Re: Charity Mom's Child Learning Center/ 833 Gibson Blvd. SE
Request for Certificate of Occupancy
Transportation Development Final Inspection
Architect's Stamp dated 10-24-2022 (L14-D057)
Certification dated 06-14-23

TRAFFIC CERTIFICATION

CHARITY MOM'S LEARNING CENTER

TRAFFIC CIRCULATION LAYOUT
SCALE: 1" = 20' - 0"

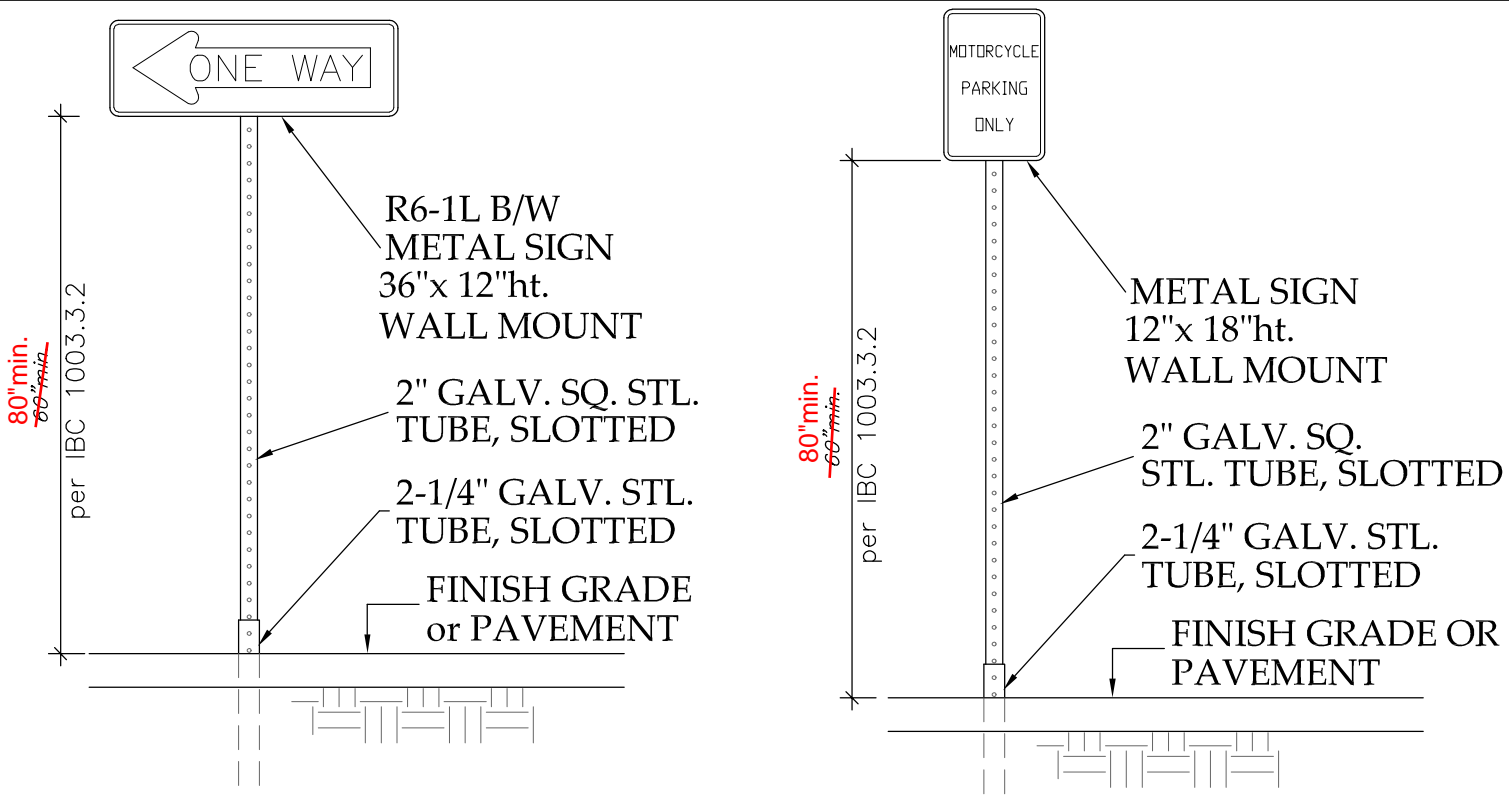
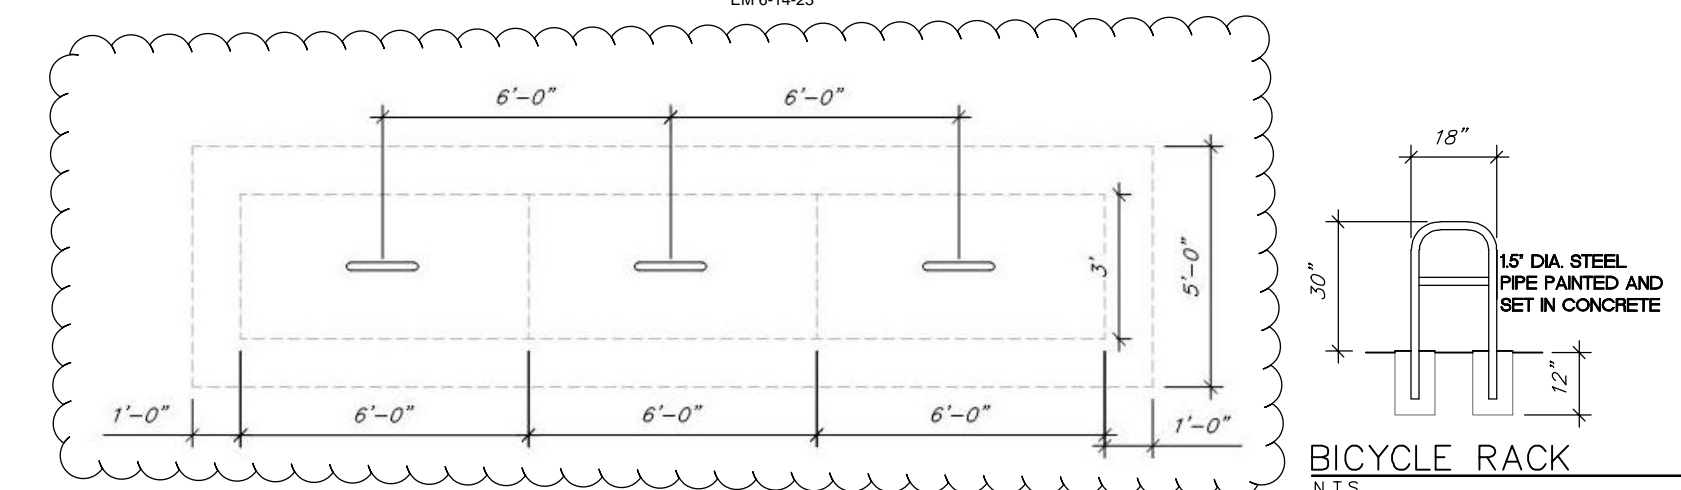
Site Plan Construction Changes are shown in redmarks on the TCL site plan herein.

EM 6-14-23 TCL AS-BUILT CERTIFICATION
